**From:** Bill Sperry [bill.sperry@mcgillengineers.com]  
**Sent:** Friday, April 01, 2011 3:47 PM  
**To:** Werner, Elizabeth  
**Cc:** mark.cathey@mcgillengineers.com  
**Subject:** Henderson County  
**Attachments:** McGill logo & text medium.jpg; 3 - C-101.pdf; 7 - C-103.pdf; 11 0401 - Extraction Well Removal.pdf

The other item we discussed pertained to the two (2) landfill gas extraction wells that need to be removed as a part of the construction of the Capital Improvements Plan. Attachment "7 - C - 103.pdf" titled "Scale Area Grading, Drainage & Erosion Control Plan" provides an enlargement of the area around the proposed Scale House where the conflict with two (2) existing landfill gas extraction wells exists. The attachment titled "11 0401 - Extraction Well Removal" is a further clarification of exactly which two wells need to be removed from the present active extraction system. This work was suppose to have been taken care of by the extraction system operator well ahead of the contractor beginning work in the area. As it happens, the extraction wells were not removed and now the contractor is ready to begin with the grading and landfill cap reconstruction in that area. W

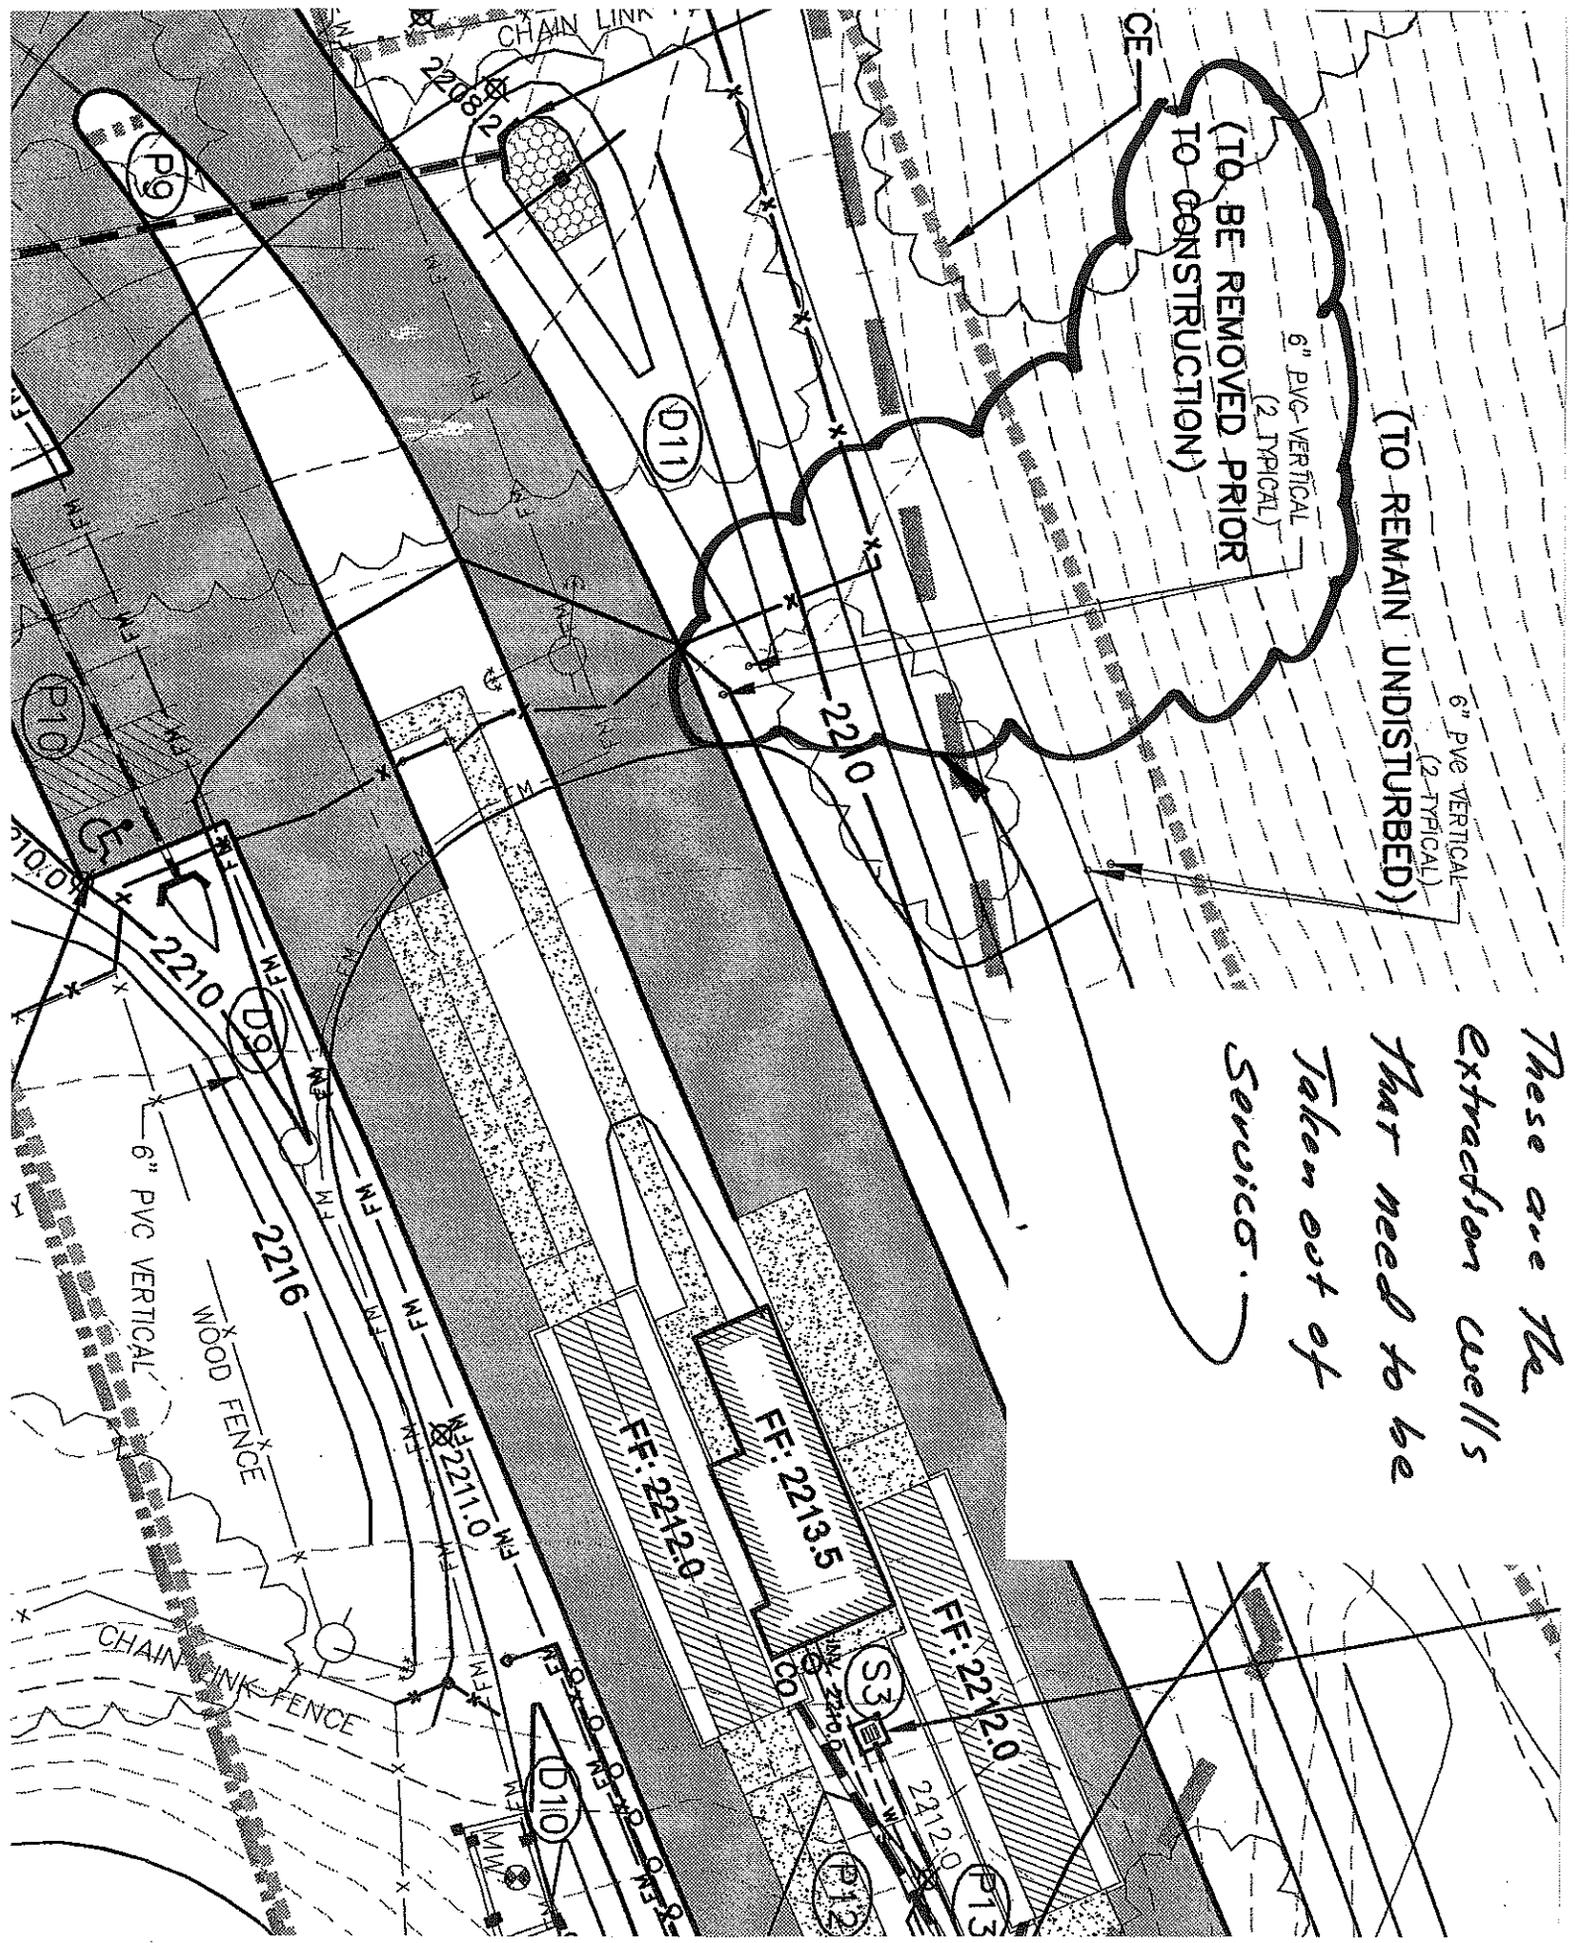
(TO BE REMOVED PRIOR TO CONSTRUCTION)

*These are the  
extraction wells  
that need to be  
taken out of  
service.*
